[Docket No. 2002-SW-22-AD; Amendment 39-12835; AD 2002-08-54]

Airworthiness Directives; Bell Helicopter Textron Canada Model 222, 222B, 222U, and 230 Helicopters

ACTION: Final rule; request for comments.

Figure 1

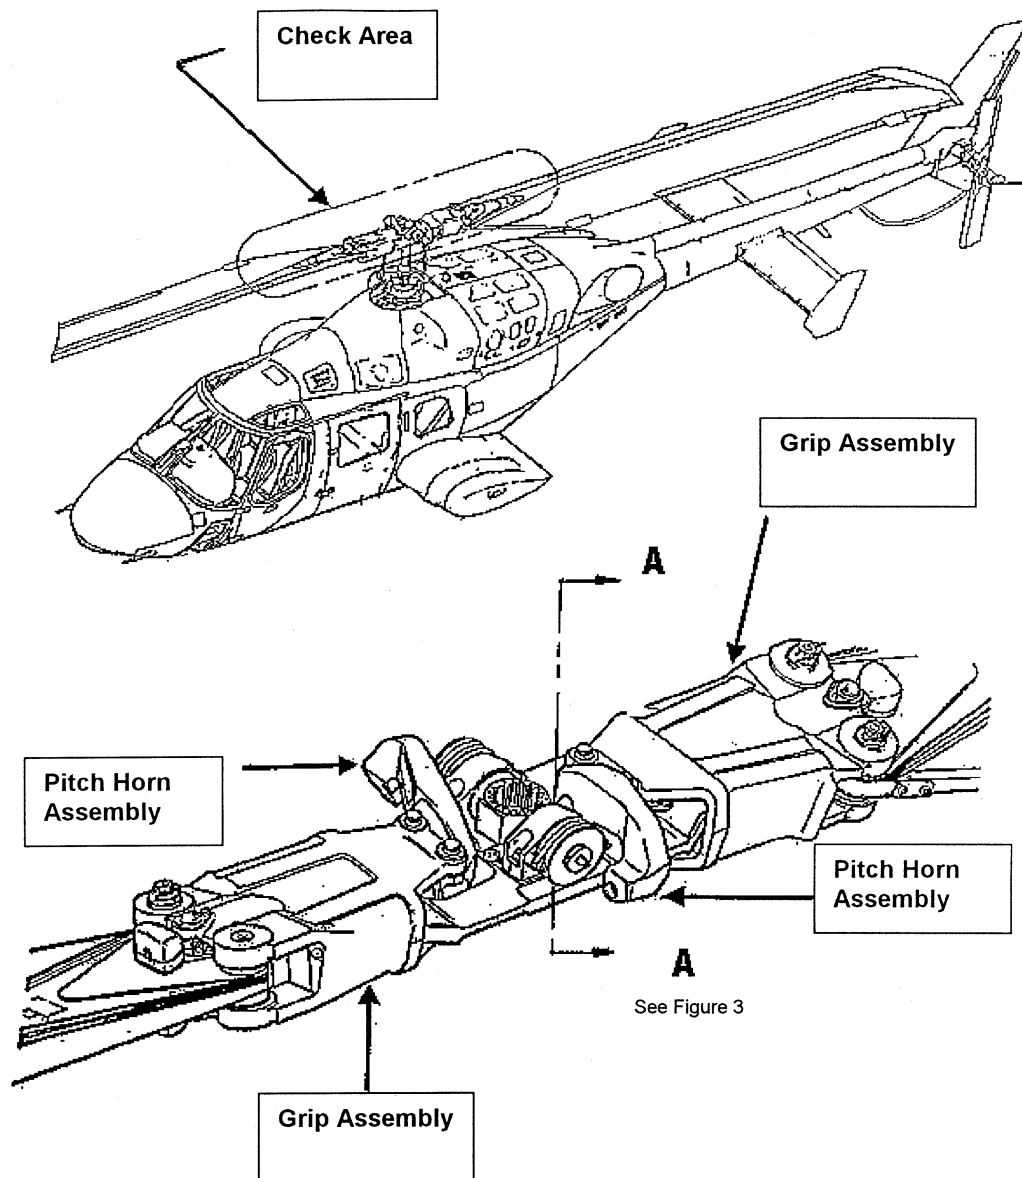
(1) Wipe clean the main rotor grip and pitch horn surfaces to remove grease and dirt in the check area as shown in Figure 1 of this AD:

Figure 2

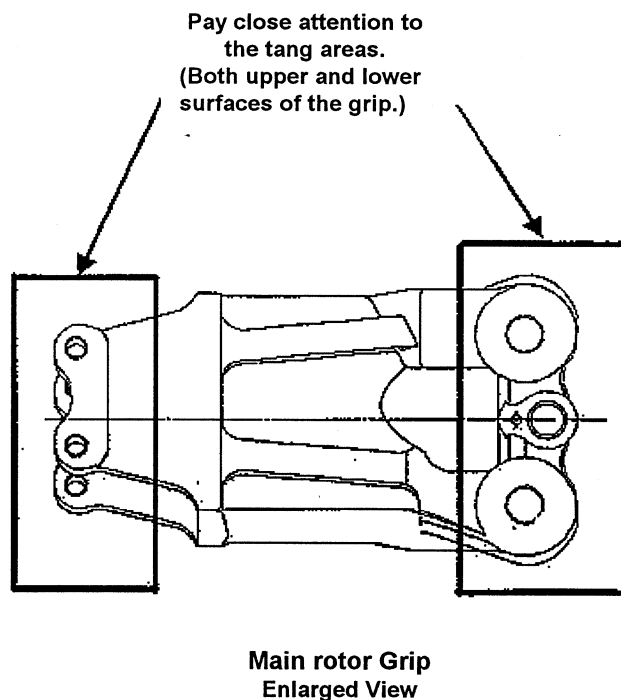
(2) Visually check both main rotor grips for a crack, paying particular attention to the inboard and outboard tangs/portions of the grip, which are in direct contact with the pitch horns and the main rotor blades. Check the area to at least 3 inches beyond the grip/pitch and grip/blade contact areas as shown in Figure 2 of this AD:

Check entire surface of the grip.

Figure 3

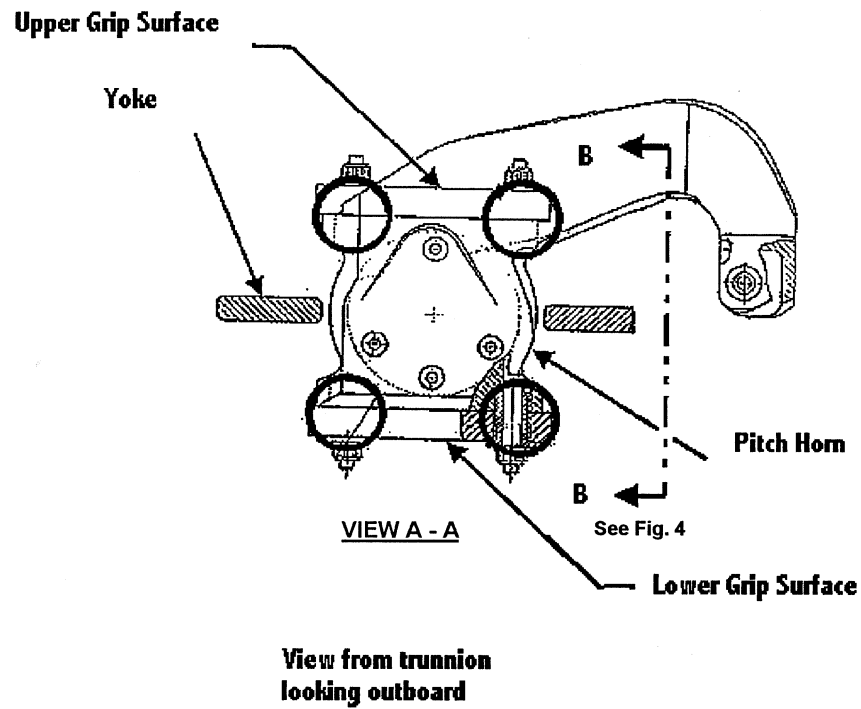
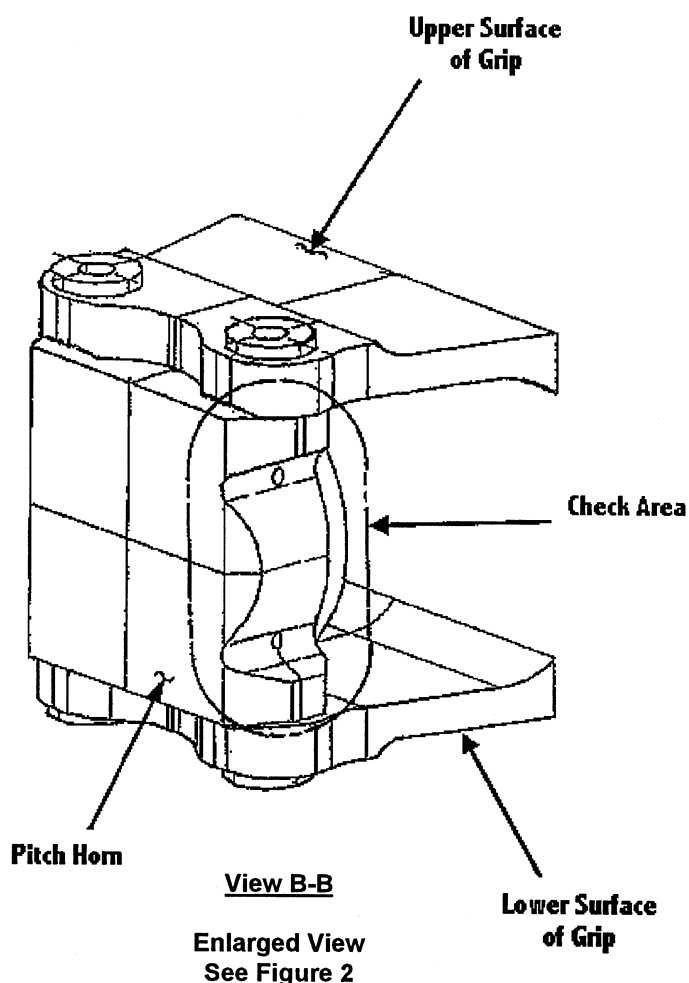
(3) Visually check all visible portions of each pitch horn for a crack. Pay particular attention to the attachment lugs of the pitch horns, which are in direct contact with the inboard tangs of the main rotor grips, as shown in Figure 3 of this AD, and the four large bolt cutouts, as shown in Figure 4 of this AD:

**All visible portions of the pitch horn must be checked.
Pay particular attention to the circled areas shown above and View B-B, Fig. 4.**
